1 Products affected

2 Type of change

Product Change Notification						PCN 5200	
owner	creation date	release date	released by	change order no	rev	page	D10-007-430
schaidro	2016-08-24	2016-12-07	blumhe	2011605	A	1 of 2

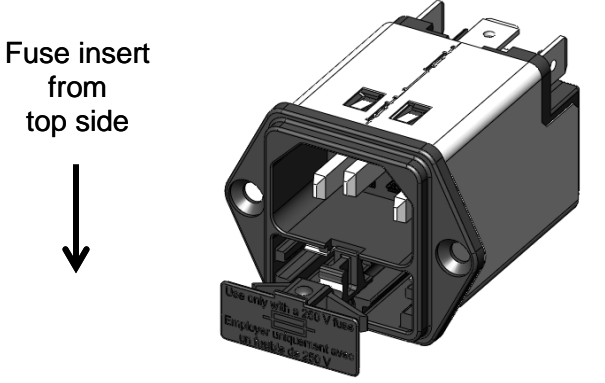
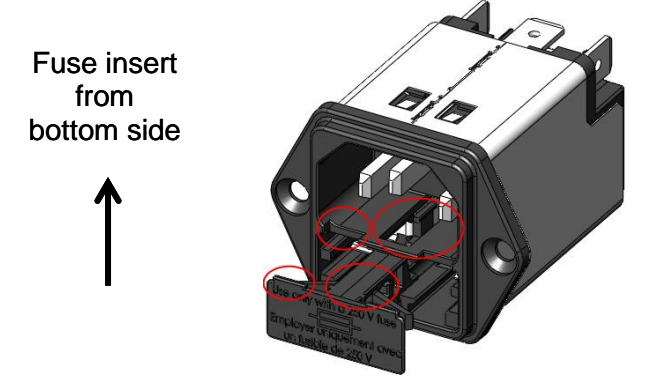
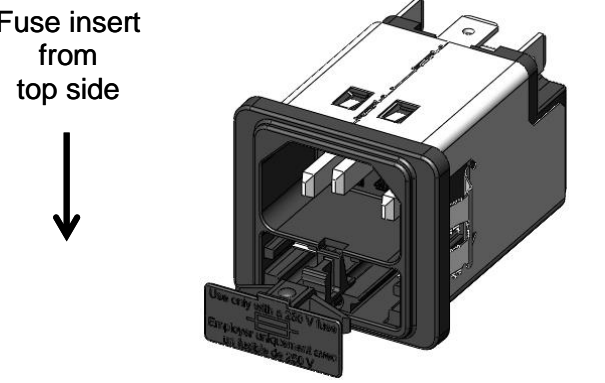
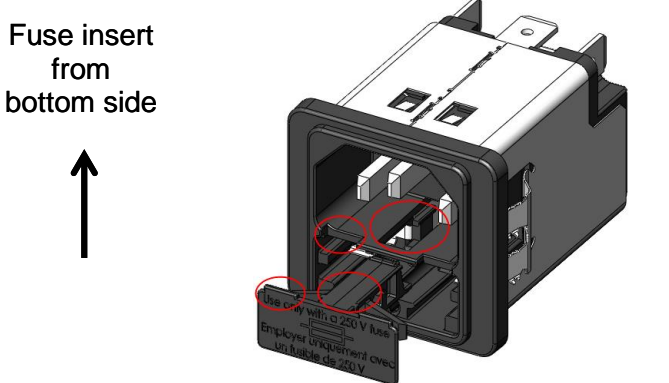
Old product appearance		New product appearance	
<ul style="list-style-type: none"> - Slot for V-Lock cord retention - Fuse assembling from opposite side - Fusedrawer has two latches on the side to pull-out the fusedrawer, until now is only one latch 			
Screw-on mounting; Old Fuse insert from top side 	Screw-on mounting; New Fuse insert from bottom side 		
Snap-in mounting; Old Fuse insert from top side 	Snap-in mounting; New Fuse insert from bottom side

Form	Yes	- Slot for V-Lock cord retention - Insertion of the fuse is changed to bottom side - Fuse drawer has 2 latches sideways
Fit	No	No dimensional change
Function	Yes	Compatible with V-Lock cordsets
Production Site	No	No change of the production site
Product Label	No	No change
Customer Action	No	Notification only

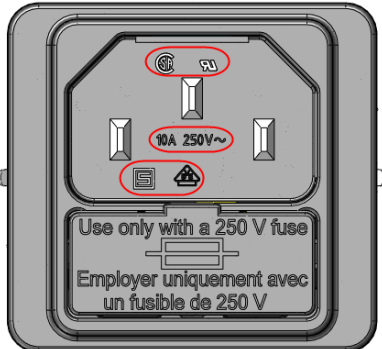
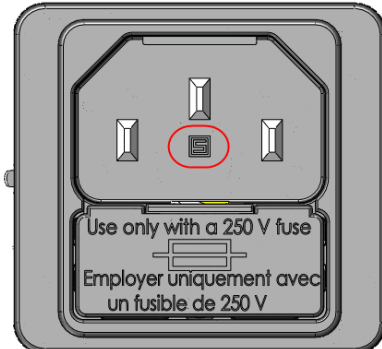
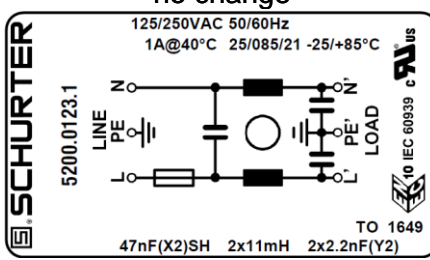
Old product approval marks	New product approval marks
Picture show is snap-in mounting, change also applies to screw version. No approval and rating marks on the IEC connector.	
Old; 	New; 
no change
